STAFF RECOMMENDATION 1000 Gilmore Avenue June 20, 2018

Application: New construction – addition; Setback determination
District: Waverly-Belmont Neighborhood Conservation Zoning Overlay
Council District: 07
Map and Parcel Number: 11801018600
Applicant: Kaitlyn Smous - Nine12 Architects
Project Lead: Sean Alexander, sean.alexander@nashville.gov

Description of Project: The applicant is proposing to enlarge the house with a rear addition consisting of three parts: an upperstory rear addition, a one-story rear addition, and a one and one-half story wing at the rear of the lot. The addition will extend the depth of the house to one hundred, fourteen feet (114') and will be wider than the historic house. A right side setback reduction from ten feet (10') to four feet (4') is requested to accommodate an uncovered side porch on the addition.

FIRST FLOOR PLAN

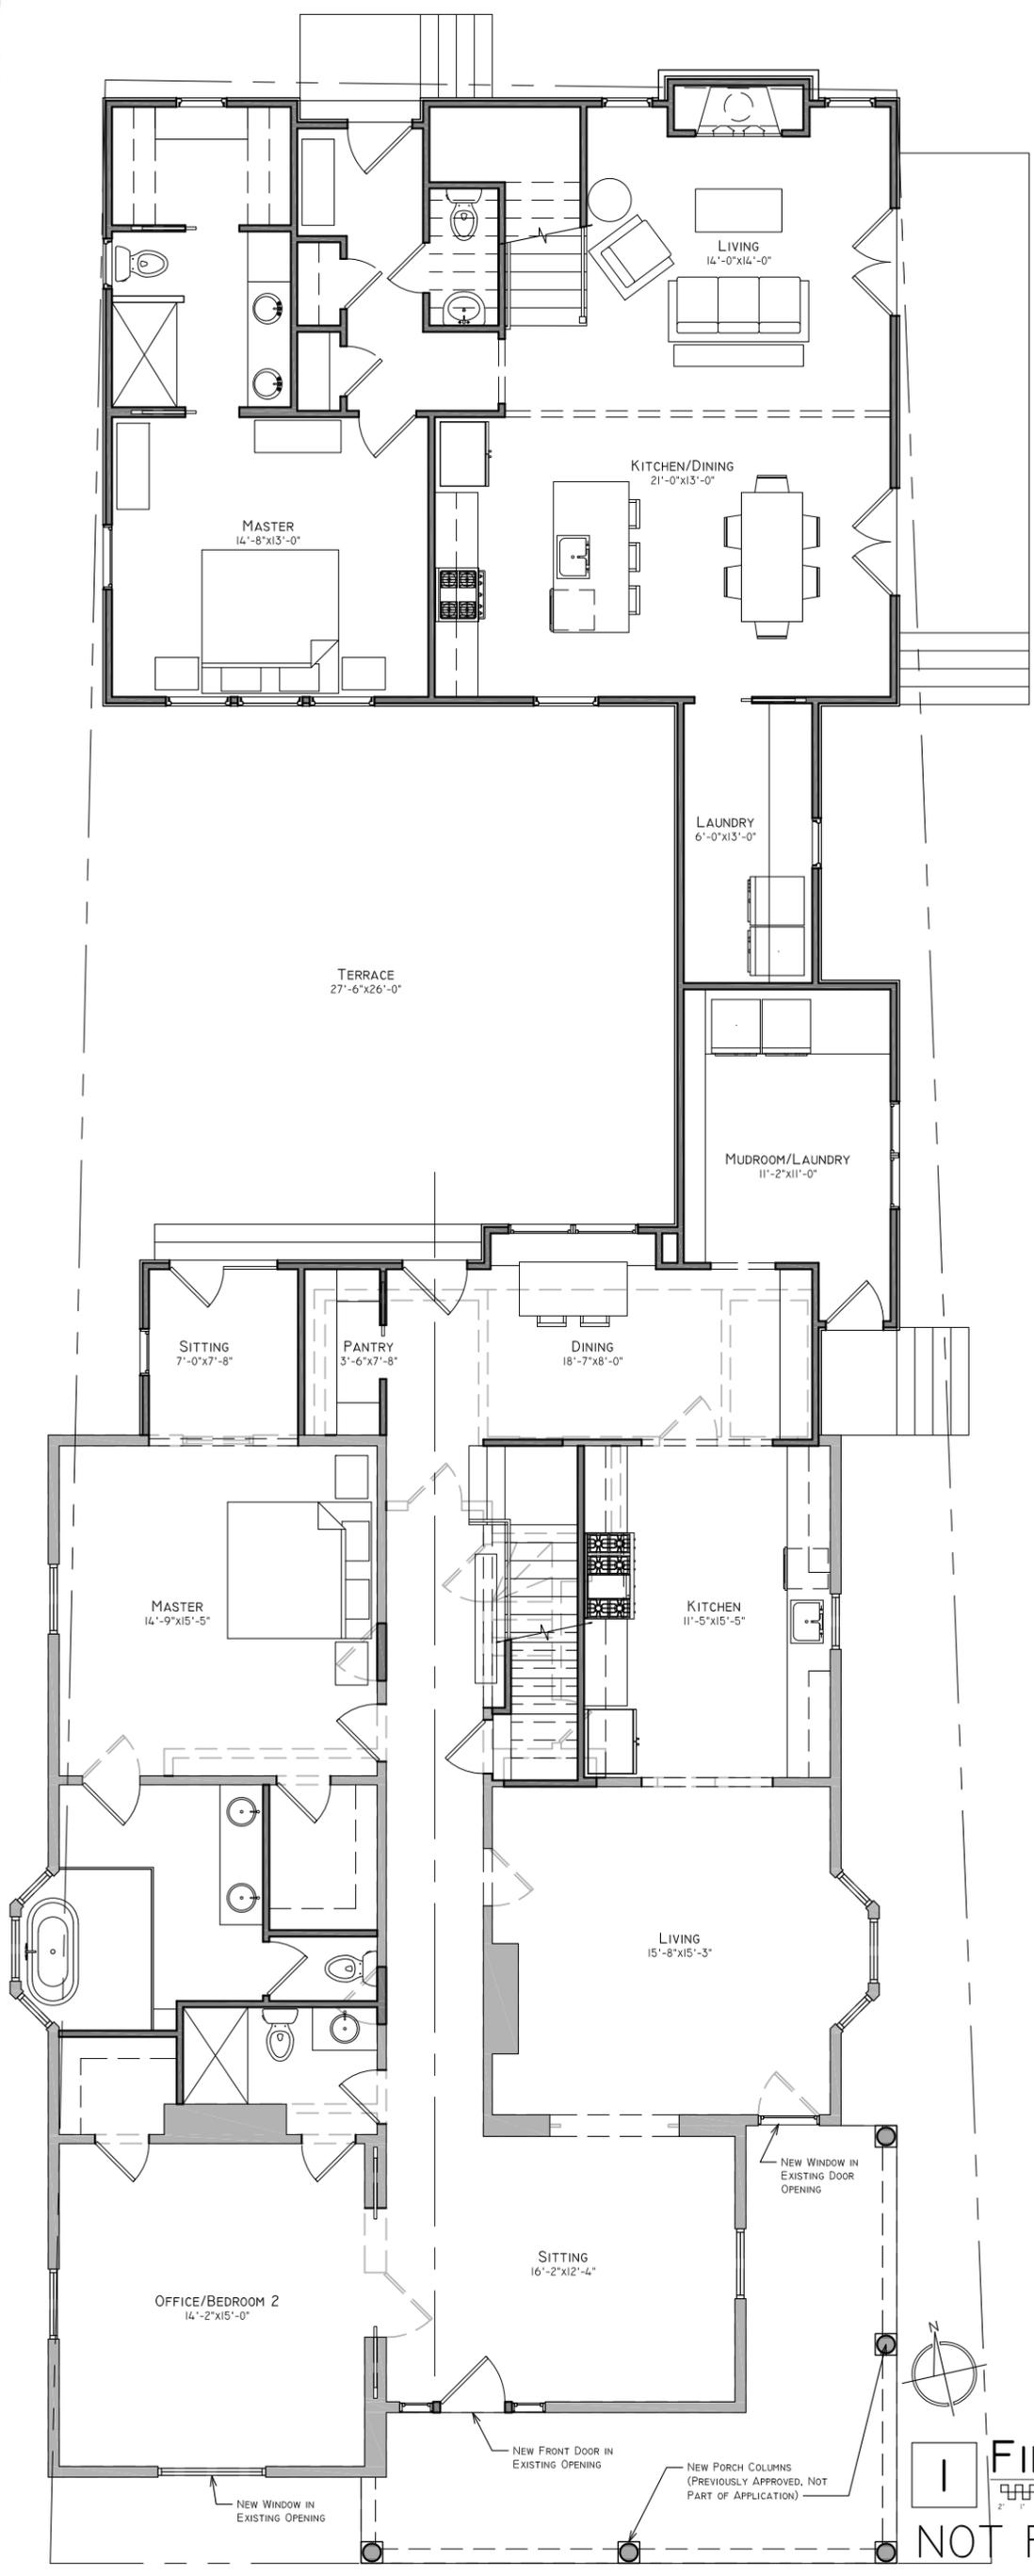
The additions extend toward the rear with walls articulating in and out, continuing all the way to the very rear of the buildable area of the lot. In total, the resulting structure would have a depth of one hundred, fourteen feet (114'), which is significantly greater than any historic house in the neighborhood. At fifty-nine feet (59') including the earlier rear addition, the existing building is already deeper than many historic houses in the area and deeper than the typical addition to a historic home approved by the Commission in the past. 1000 Montrose Avenue, for example, has a similar Folk Victorian form and is on a larger lot but is only sixty feet (60') deep. The depth of the proposed addition will be less noticeable along the left side of the building because it faces the interior and is more inset more, but because the right side faces 10th Avenue South directly the scale will be much more noticeable. Furthermore, the combined depth with the new construction results in there being the appearance of there being much less open space remaining on the lot than is typically found in the district. For this reason also, Staff finds that the proposal does not meet section III.B of the design guidelines.

After inseting one foot (1') and extending eight feet (8') toward the rear, the addition will step out three feet, nine inches (3'-9") to the right. Although the walls of the addition articulate in and out, a combined forty-four feet (44') of the addition's depth would be sitting two feet, nine inches (2'-9") to the right of the primary wall of the house. These portions of the addition would align with the edge of the front porch, however, in determining the appropriateness of additions previously, the Commission has generally compared the width of an addition to the primary mass of an historic building rather than open and secondary elements like a porch or a bay.

The rear-most section of the addition also includes an uncovered deck on the right side, spanning twenty-two feet (22') and extending six feet (6') toward 10th Avenue South. The guidelines say that side additions or additions wider than historic houses may be appropriate on lots that are wider than sixty feet (60'), on houses that are less than thirty feet (30') wide, or houses that are shifted to one side of its lot. Although the forty foot (40') wide house at 1000 Gilmore Avenue is not centered on the lot, Staff finds that the proportion of the addition and the amount that it will be wider than the historic house is too substantial, and that the proposal fails to utilize space behind the building where an addition would have smaller scale and less impact.

1. The depth of the addition shall be reduced to be subordinate to that of the historic house;
2. The walls of the addition shall not be wider than the primary massing of the historic house;
3. The addition shall not encroach into the side setback buffer; and
4. The material of side and rear porch floors and walkway paving materials are approved administratively, as well as the window and door selections;
5. Four inch (4') mullion between paired windows; and,
6. The HVAC and other utilities shall be located on the rear façade, or on a side façade beyond the midpoint of the building.

ELEVATIONS

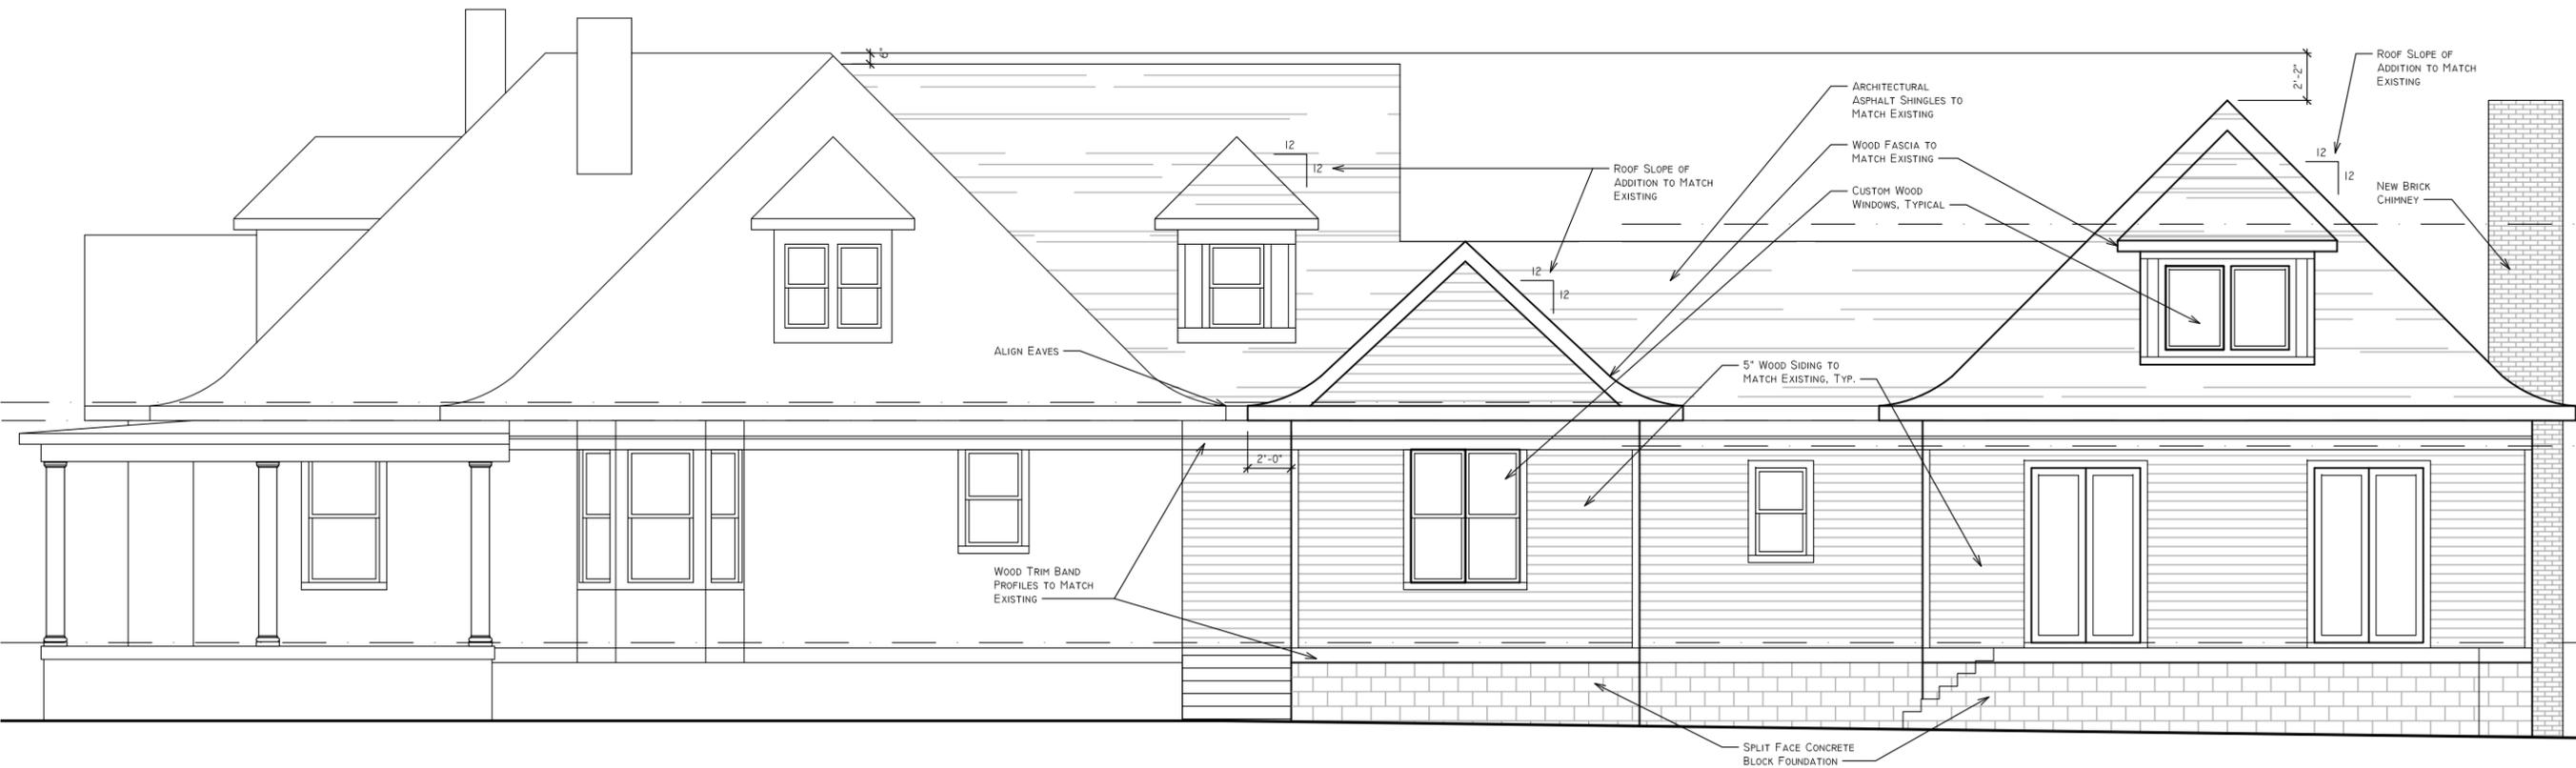
Height & Scale: The addition will have three components: a rear upperstory addition, a one story rear addition, and lastly a one and one-half story wing at the very rear. The upperstory addition will tie into the rear slope of the historic house approximately six inches (6") below the peak of the roof. The one story component will have side walls stepped in one foot (1') on each side of the house. The one and one-half story component will have a hipped roof similar to that of the original building, but will be two feet (2') shorter than the original roof peak. The eaves of the one story and one and one-half story additions will align with the eaves of the historic house. Staff finds the height of the addition to meet meets section IV.B.1 IV.B.4, and IV.B.6 of the design guidelines.

Roof form: The roof of the addition will consist of hips and gables, similar to the forms of the original roof and matching its 8:12 pitch. The upperstory rear addition and the rear-most one and one-half story section of the addition will have hipped forms, matching the form of original dormers on the historic house. The front and side slopes of the original roof will be left intact. Staff finds the roofs to be compatible and that the project meets section III.E for new construction-roof form and IV.C for additions.

The majority of windows on the proposed addition are twice as tall as they are wide, in keeping with the proportions of windows on the historic house. There are no large expanses of wall space without a window or door opening. Staff finds the project's proportion and rhythm of openings to meet Section III.G of the design guidelines for new construction-proportion and rhythm of openings.
